M-32  
PDR/LPDR

SUBJECT: Enclosures

REVIEW AND DISCUSSION OF VERTICAL FRACTURES REPORTED AT WV SITE:  
working draft

Raymond C. Vaughan  
Coalition on West Valley Nuclear Wastes

Figure 5. Generalized east-west cross section of glacial deposits at the Western New York Nuclear Service Center.

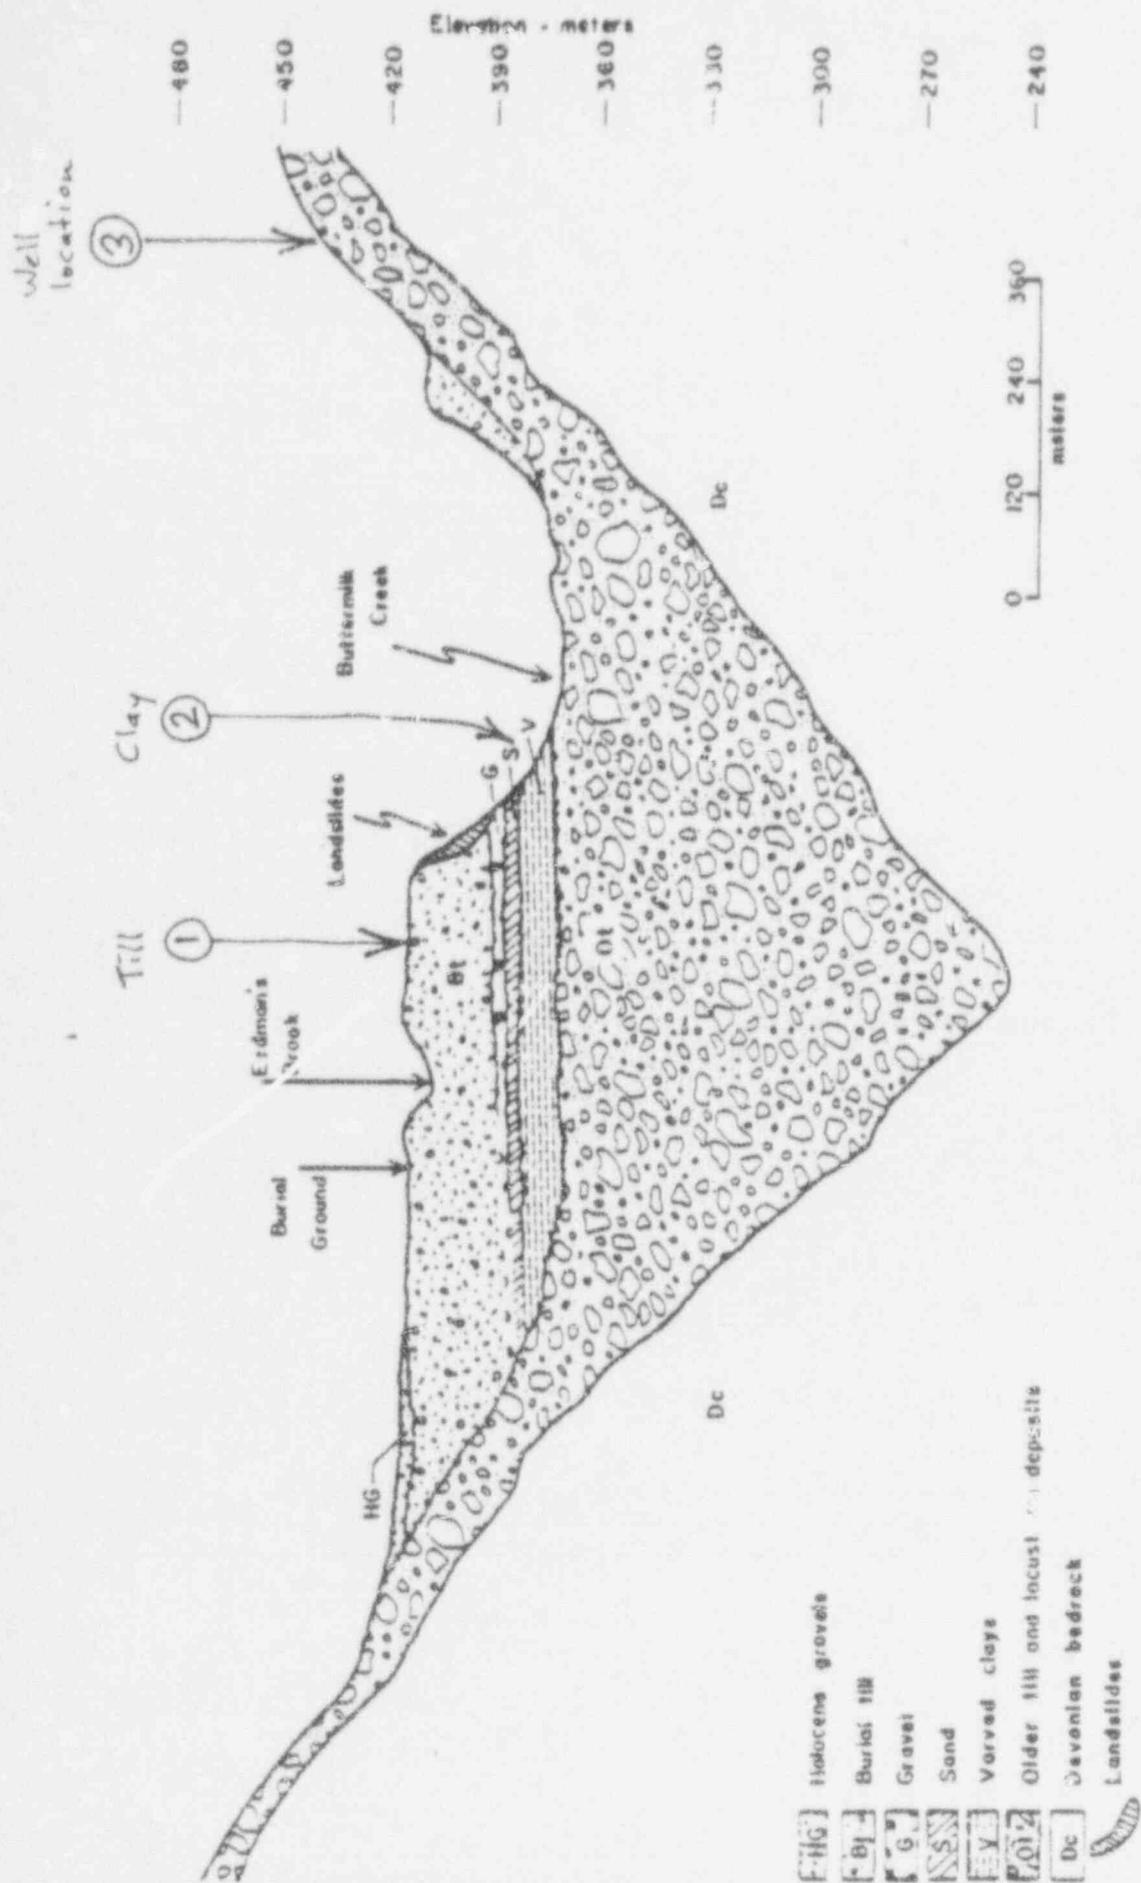
Belcher's statement about the problem of transmitting joint patterns up through thick layers of glacially deposited material brings us to the major site-specific discrepancy at the Western New York Nuclear Service Center. The attached cross-section of the relevant portion of the Buttermilk Creek valley shows the problem: The fractures observed in till and clay are more than 100 meters [more than 300 feet] above the bedrock floor of the valley. It is difficult to believe, especially in the absence of either a clear-cut example or a well-understood mechanism, that relatively minor bedrock joints can project themselves upward through such a thickness of multi-layered glacial deposits.
